THRUSH AIRCRAFT, INC.

SERVICE BULLETIN

No. SB-AG-50

PT6A-60AG P3 LINE CHAFING

FIGURE 50-1: P3 Line and Lower Right Engine Mount Bracket
View looking up from behind mount ring

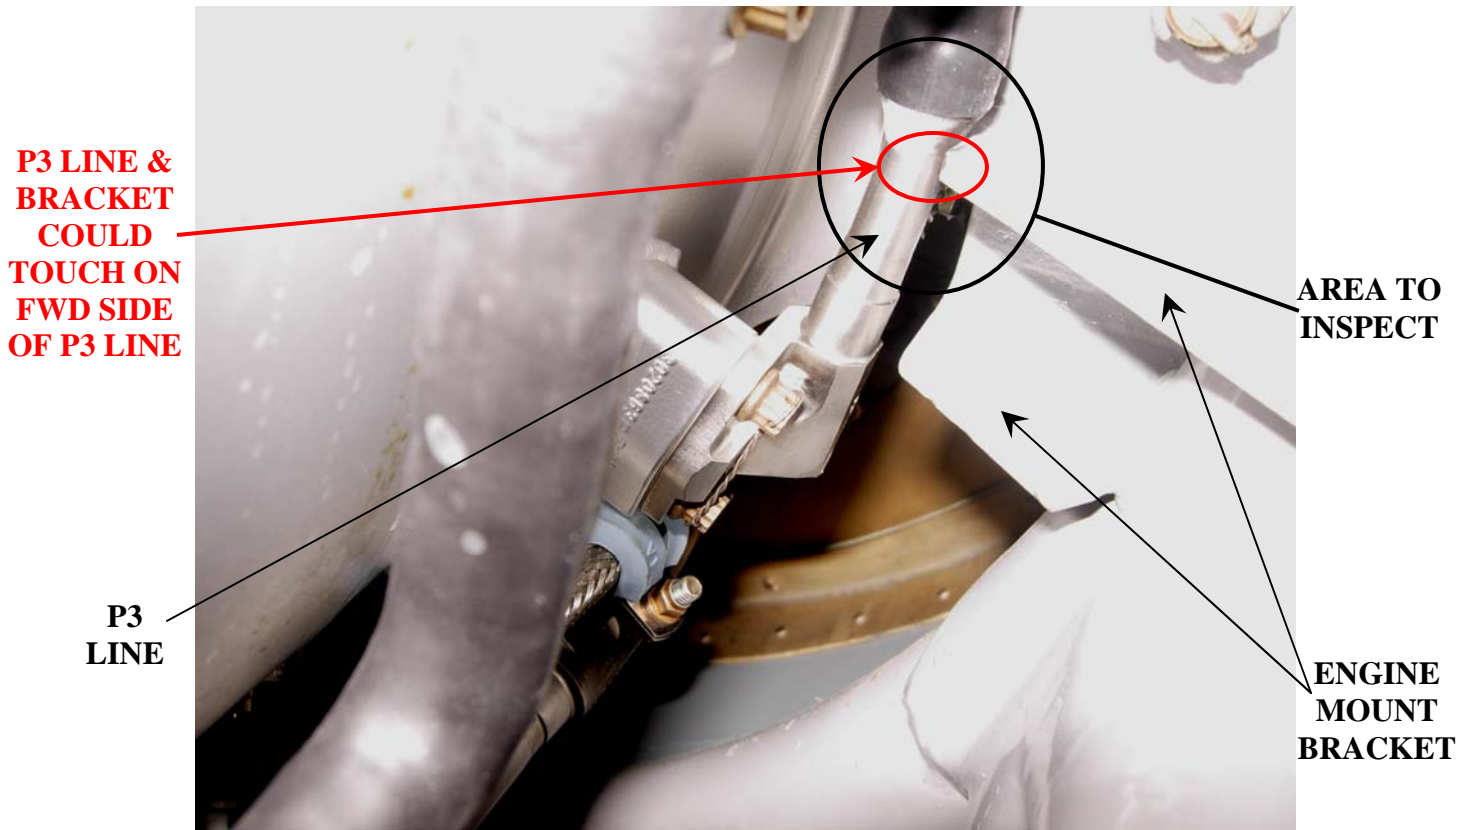
Locate the P3 line attached to the engine case slightly aft of the lower right engine mount bracket (ref. Figure 50-1). The P3 line runs circumferentially counter-clockwise from the engine case pressure tap, turns aft through the fireseal and then goes to the fuel control.

Because of the location of the P3 line pressure tap on the engine case, the P3 line passes close to the aft side of the lower right engine mount bracket (specifically the stiffening flanges pointing aft).

Check to see that the P3 line is no closer than .20" to any part of the lower right engine mount bracket. If the P3 line meets this requirement, you need only log compliance with Thrush Aircraft, Inc. Service Bulletin SB-AG-50 in the airplane maintenance log and fill out and mail the compliance record back to Thrush Aircraft, Inc.

FIGURE 50-2: Engine Mount Bracket Trimmed to Clear P3 Line

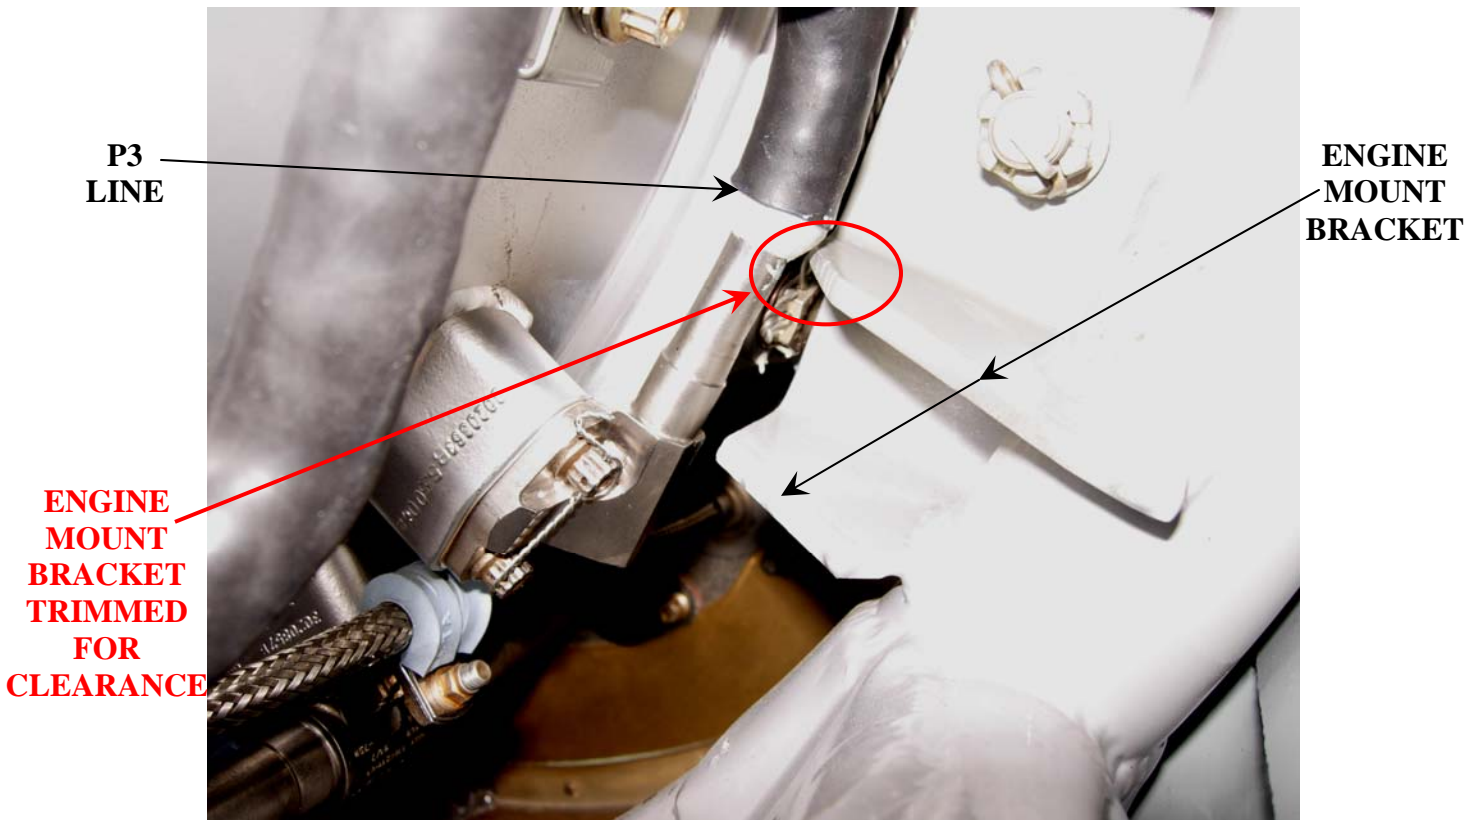
If the clearance between the P3 line and any part of the lower right engine mount bracket is not .20”, the bracket must be trimmed to gain this clearance (see Figure 50-2). Be careful not to damage the P3 line. It is recommended that the P3 line be removed before trimming the bracket. Check clearance after trimming, and when clearance is .20” or better prime and paint the exposed metal.

If the P3 line has been in contact with the engine mount bracket there will be evidence of that on the P3 line. If the damage is more than burnishing the line (ie. it is gouged or deformed), the line must be replaced before further flight.
